**RE: Town of Kittery, Planning Board Services
Site Plan Review #2
Rice Public Library (8 Wentworth Street) Tax Map 4, Lot 88
CMA #591.132**

Final Site Plan Review Application

Rice Public Library Expansion

Final Site Plan Review Application
Rice Public Library, 8 Wentworth Street

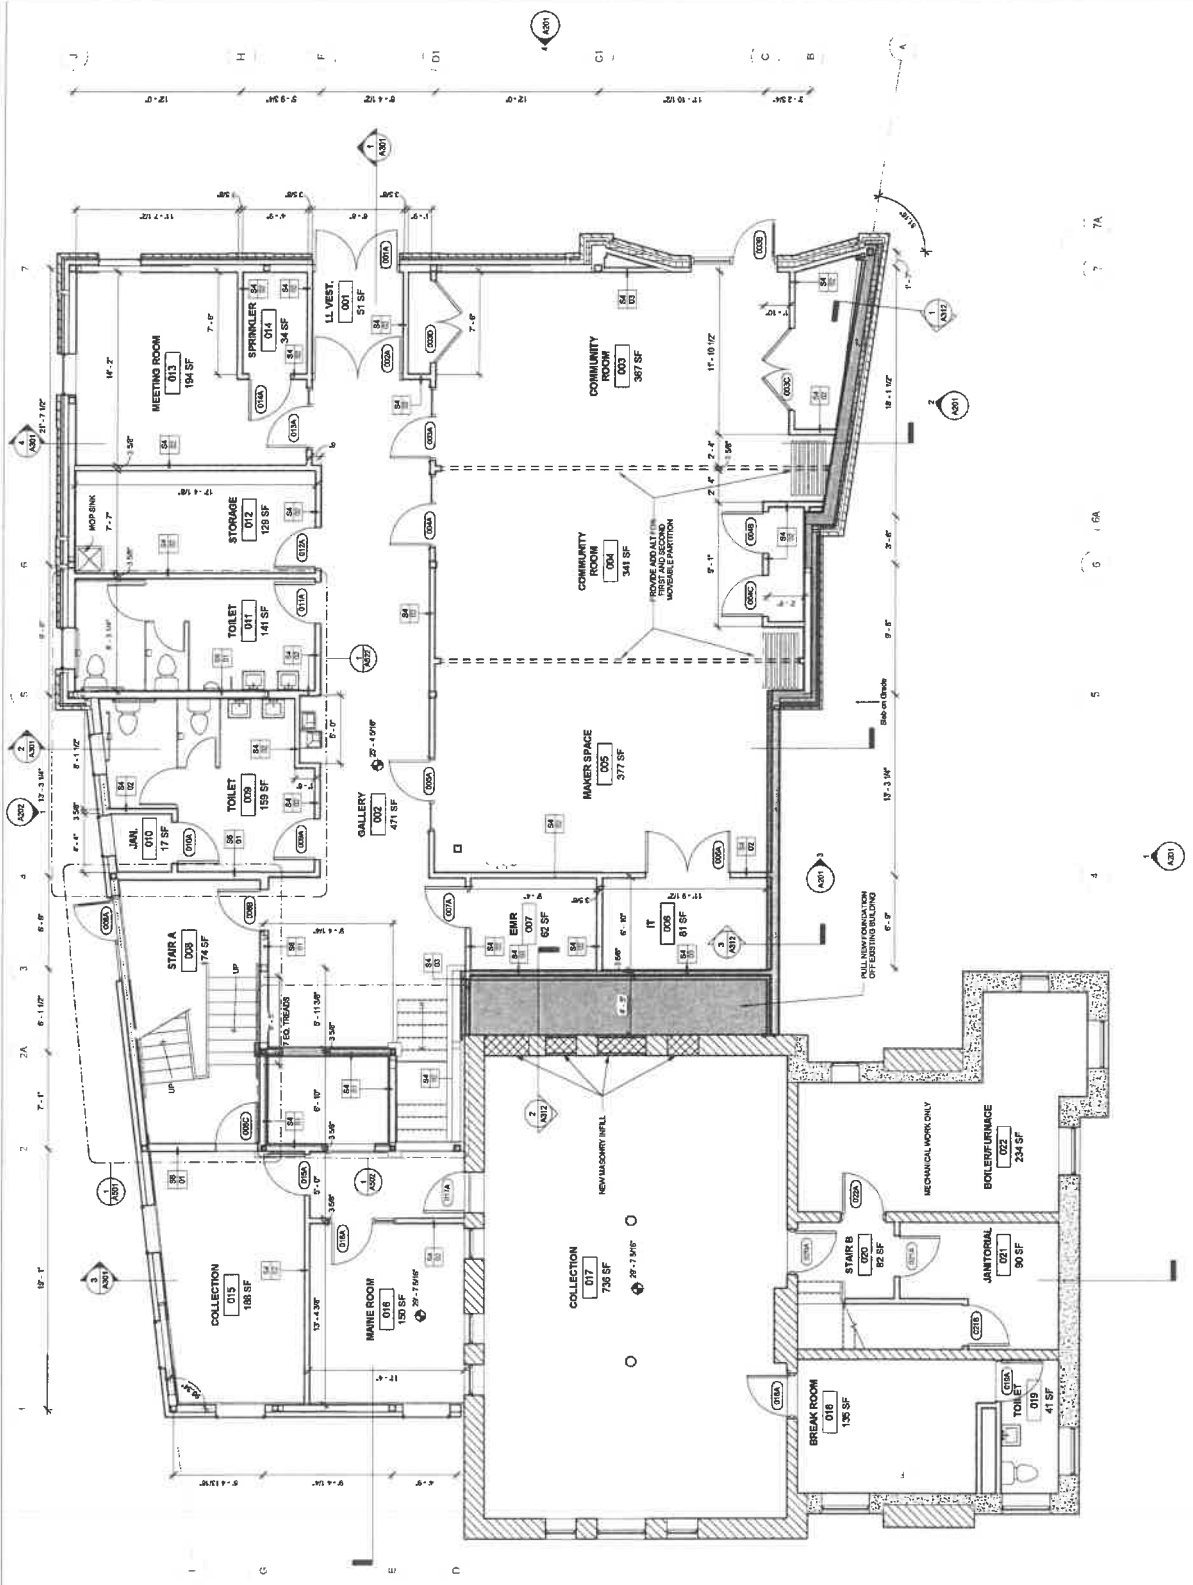
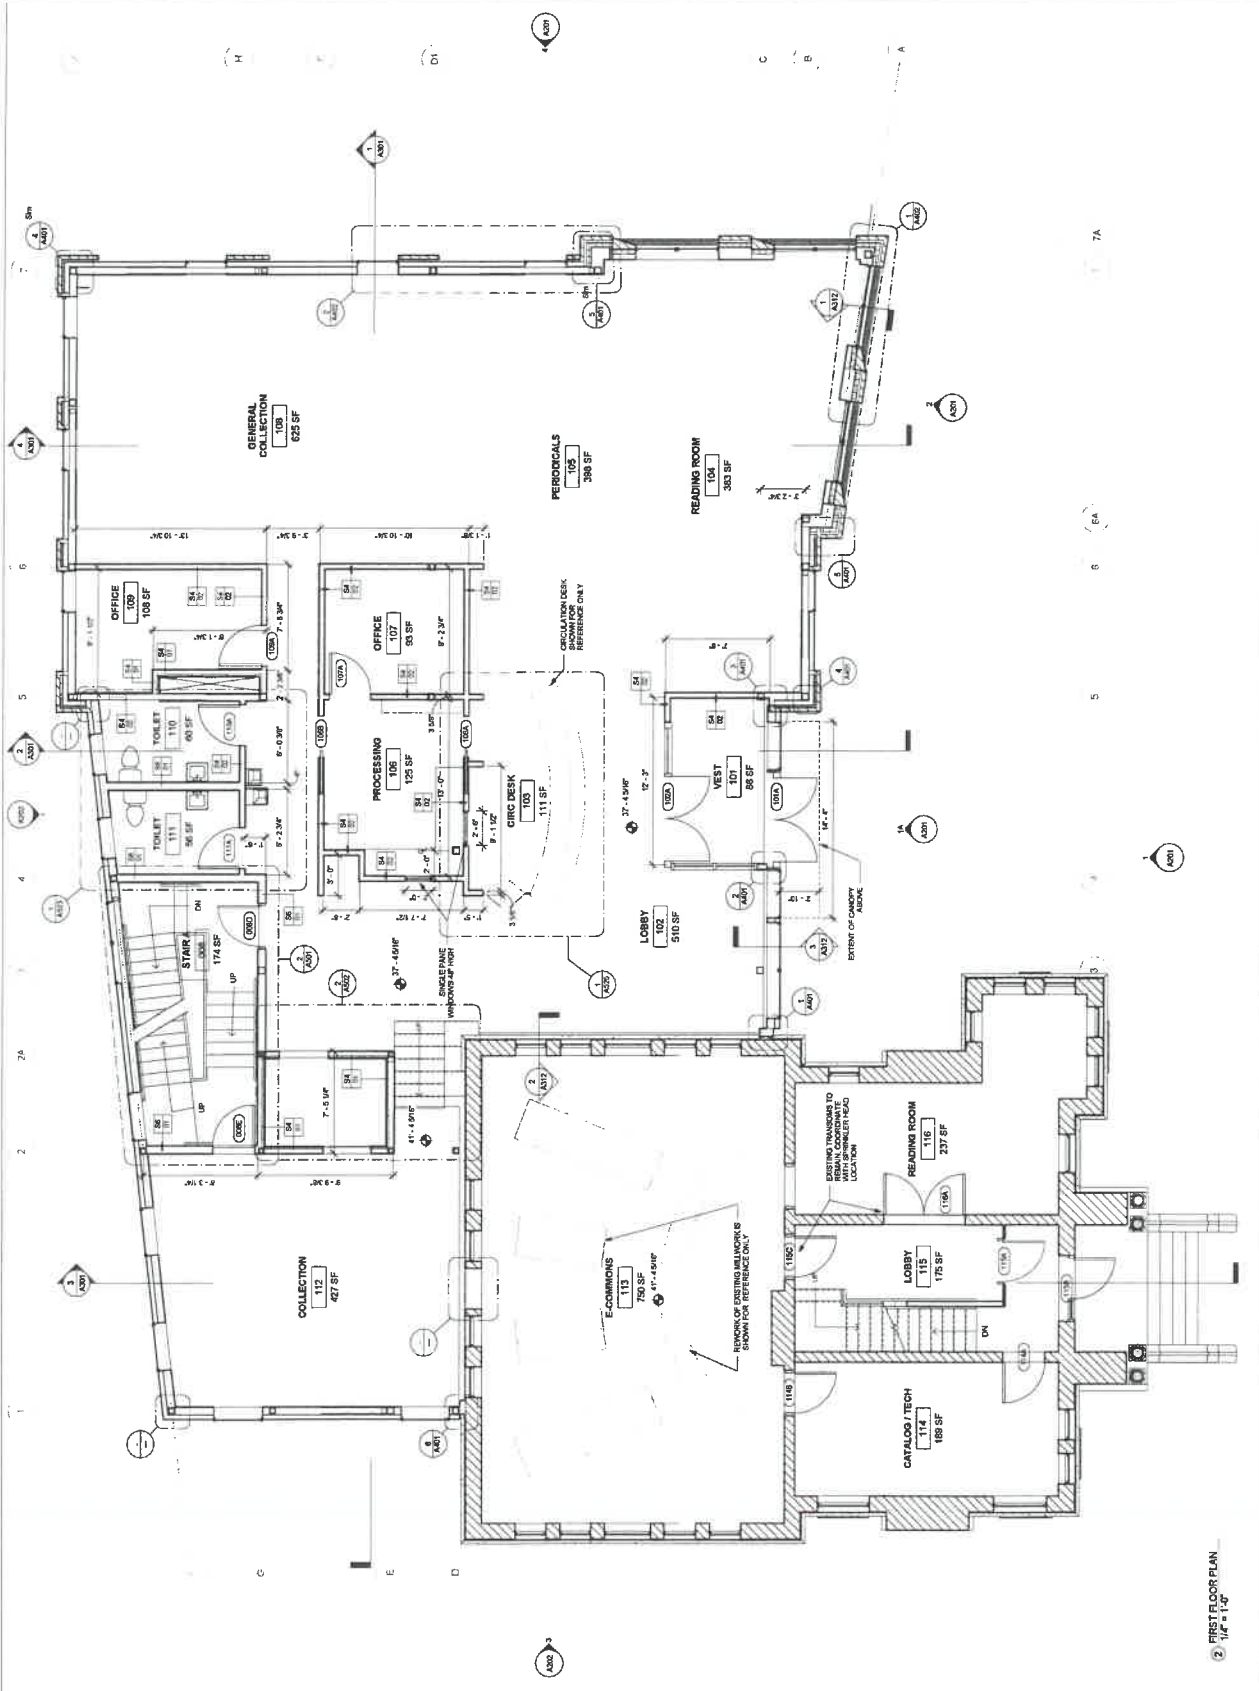
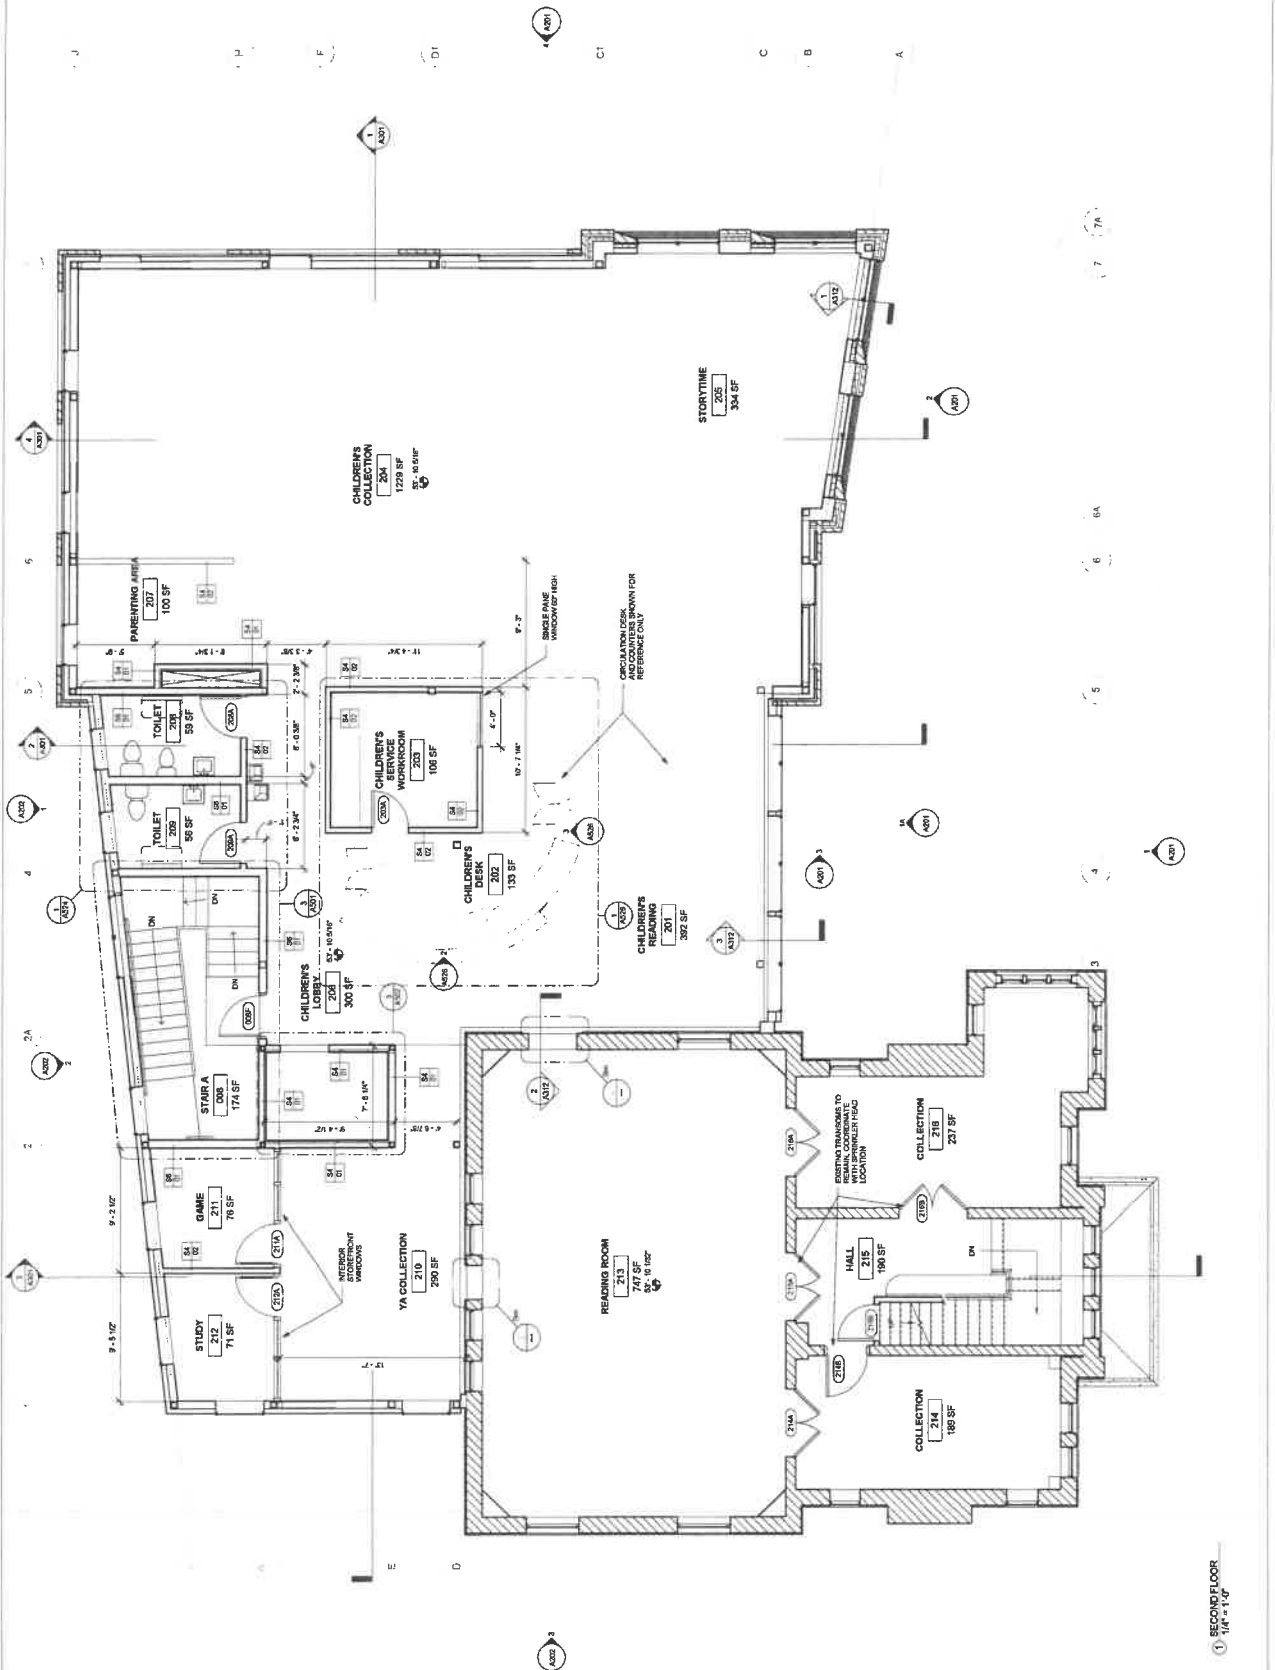
7. *As stated in the Applicant's narrative dated July, 23, 2020, a revised floor plan will be submitted to the Fire Chief to confirm the location of the mechanical room and its conformance with Fire Code standards. The Applicant should provide to the Board a timeline for that submission and subsequently submit a letter authored by the Fire Chief to the Board confirming the mechanical room's suitability*

Attached for Staff and Fire Chief review are floor plans and building elevations.

Building floorplans are provided. It is our understanding that the Technical Review team will do another review of the plans when submitted for final plan review.

BUILDING ELEVATIONS

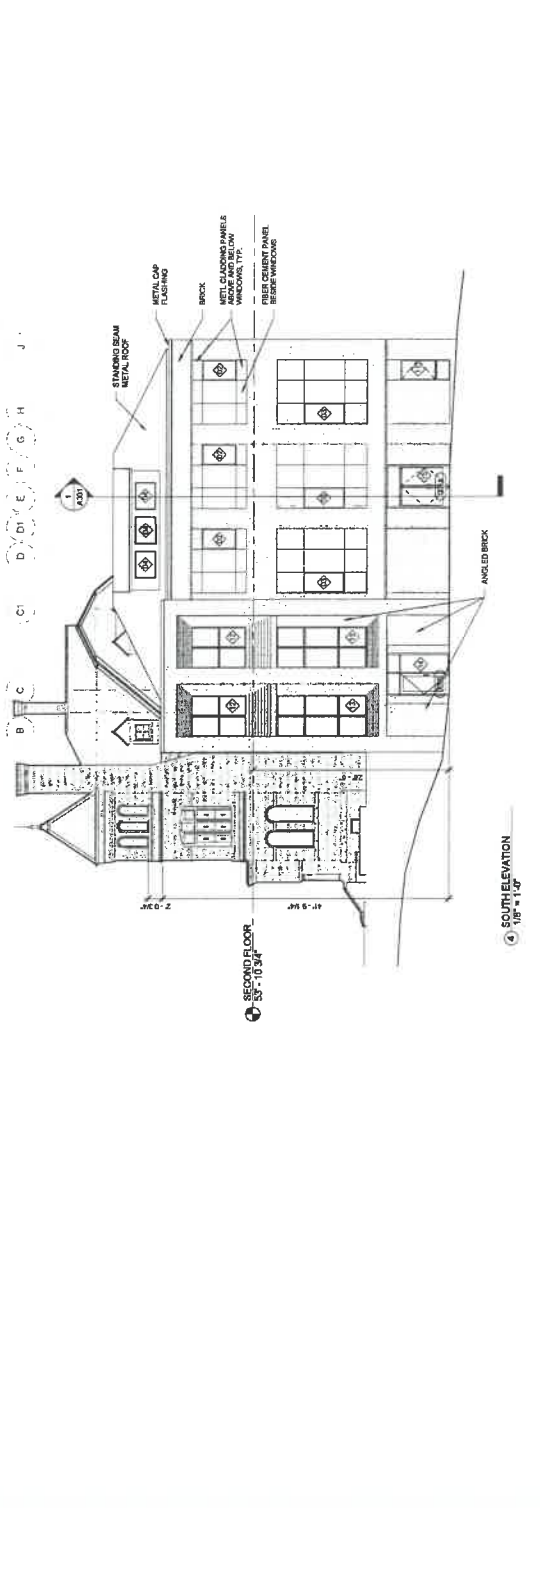
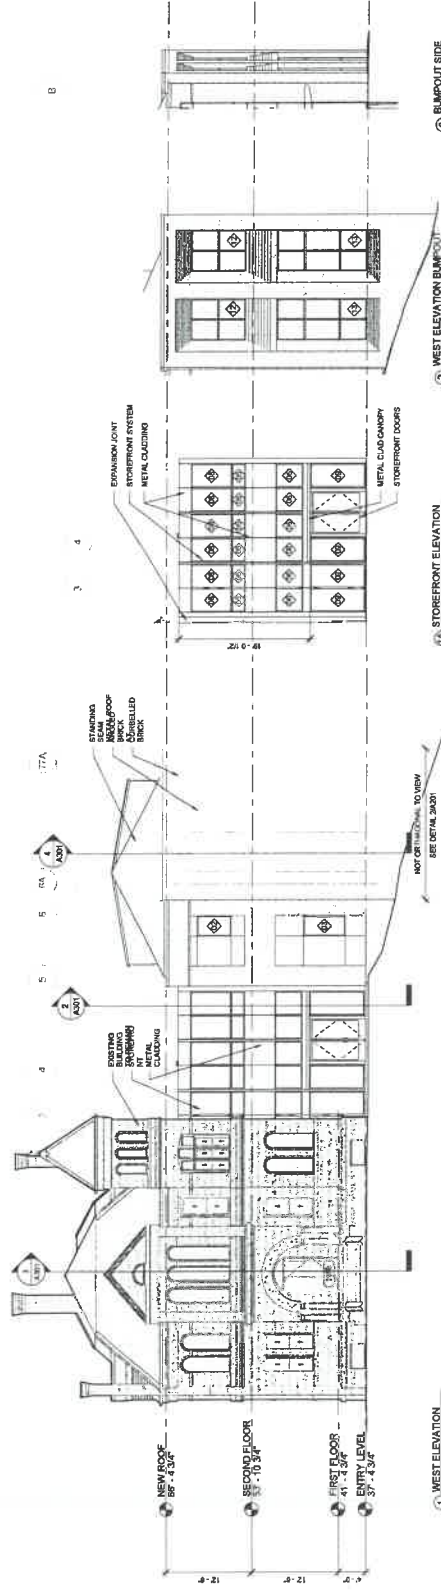
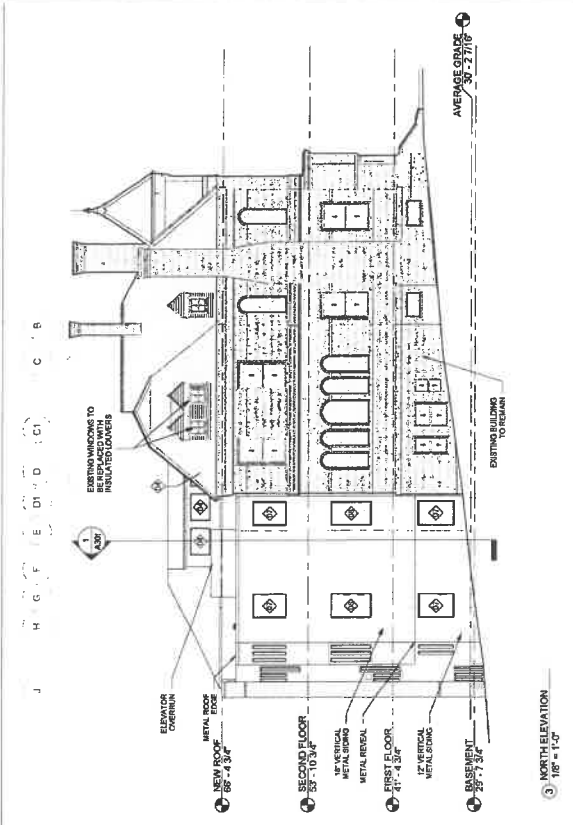
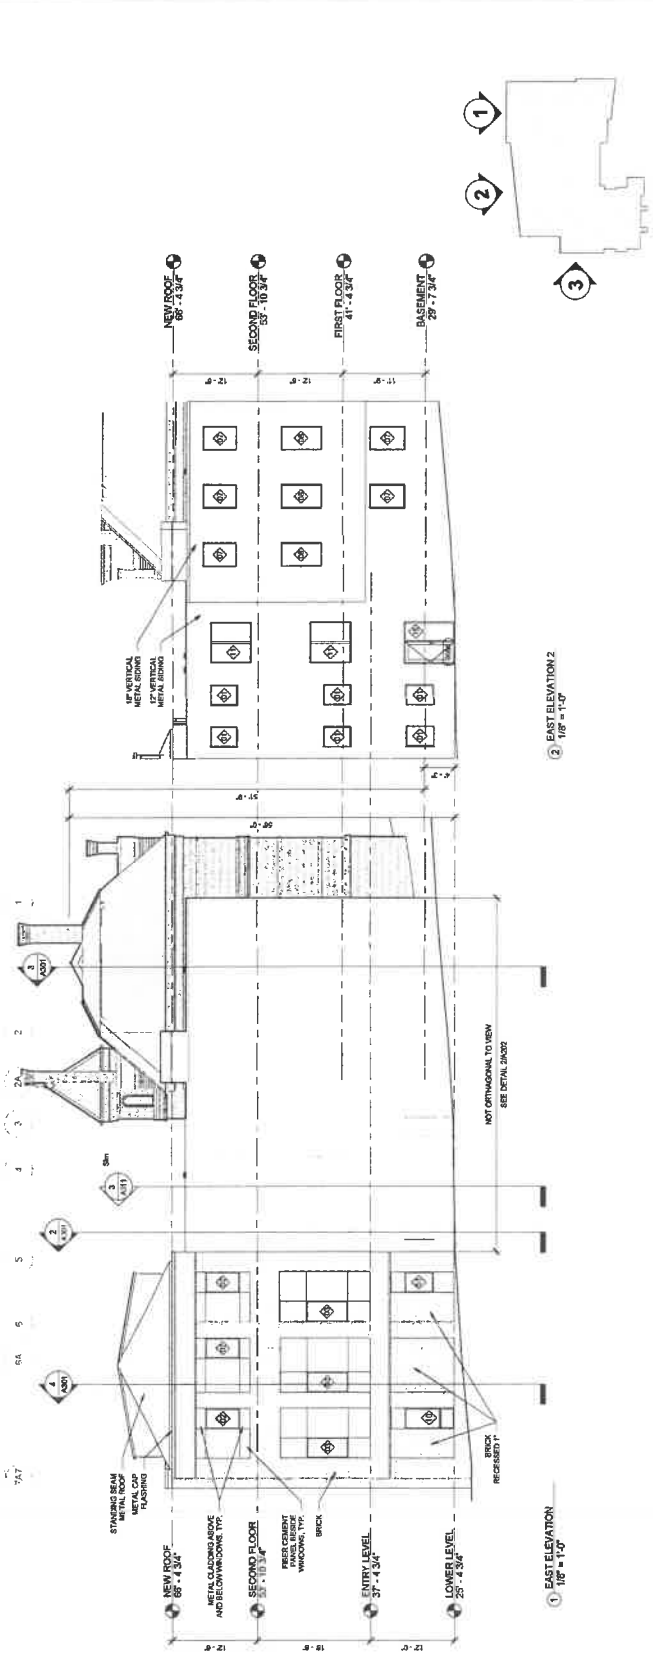
5. *Revised elevations need to be provided prior to final approval*

Attached are revised building elevations.
